THE NATIONAL GRID COMPANY plc

Revisions to the Grid Code

Consultation Paper A/01

OC5 - TESTING AND MONITORING

Diagram showing rationalisation of OC5 text to common wording

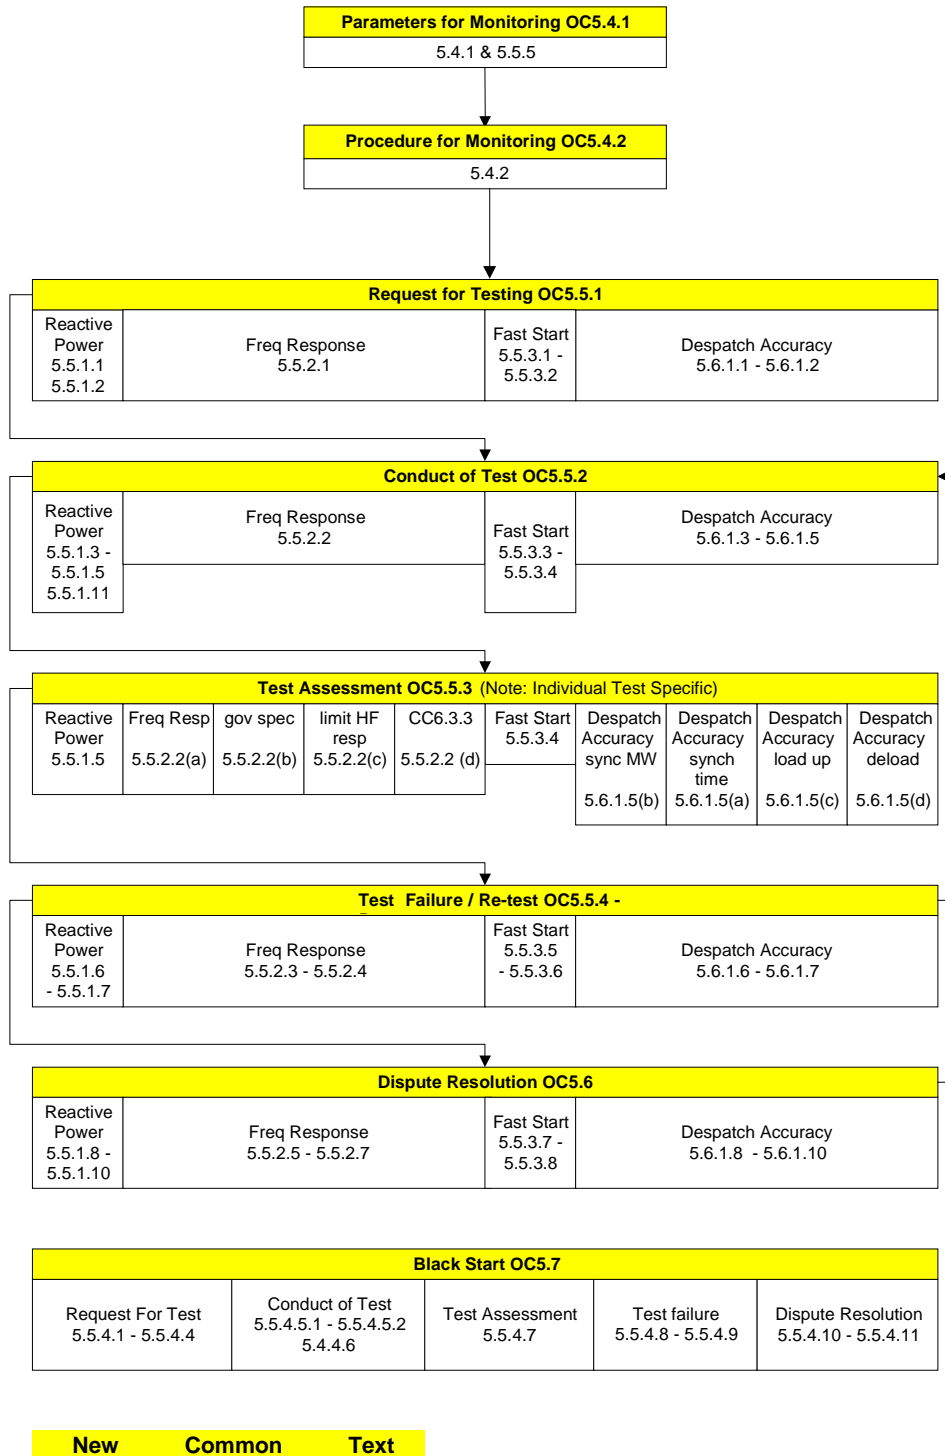
6.2 With two exceptions the revised layout for OC5 proposed by the working group rationalises all the procedures for monitoring, testing and disputes resolution into common text. A table has also been introduced to set out the assessment criteria applicable to the individual plant performance being measured. The two exceptions referred to above are:-

- the requirements for Black Start Testing, which is retained as a separate section (OC5.7), and
- the deletion of OC5.4.2.5, which relates to a sampling points methodology, as this level of detail is considered inappropriate.

6.3 Appendix A to this paper illustrates which sections of text were identified as common, and indicates the proposed structure. Appendix B comprises the proposed new wording of OC5, with changes from the existing OC5 shown by way of strikeout and underlining.
